TE Connectivity

Product Change Notification: P-26-030969

PN = 2479934 – 2POS,MQS,TAB HSG ASSY,SLD,COD A

MALE HSG / ISL FIT IMPROVEMENT

Visual reference:

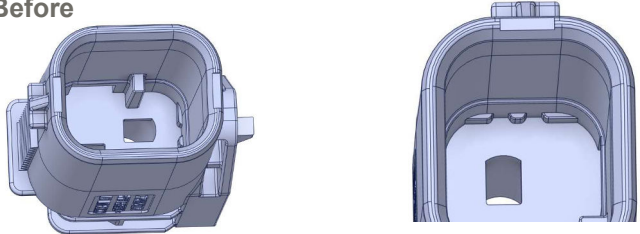
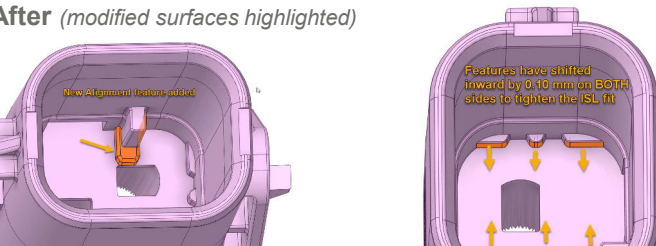
During SL inspection, multiple cases of unexpected lock activation were identified, showing an approx. 1.5% fallout rate associated with this failure mode.

An initial evaluation identified a noticeable gap between the housing and the ISL. A rattle effect is present, indicating excessive clearance between mating components. This condition may be contributing to the unwanted lock activation.
